SERVICE PROCEDURE

G-12520
July 2012

SUBJECT: NON-COMPLIANCE RECALL
Roof-mounted emergency exit on certain CE and RE bus models built 01 April 2011 through 31 March 2012 with ProLo roof-mounted emergency exits produced by Specialty Manufacturing Inc. (SMI).

ProLo Hatch Rear Support Receiver Replacement Instructions

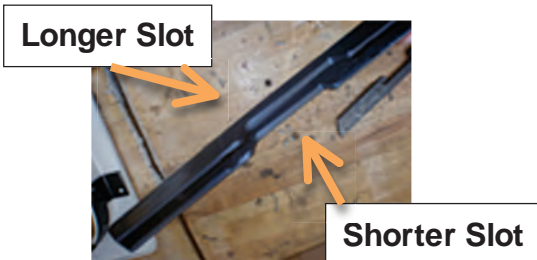
Step 4: Using an electric screwdriver with a Phillips head bit, remove the four (4) screws holding the plastic receiver to the lid and discard the screws
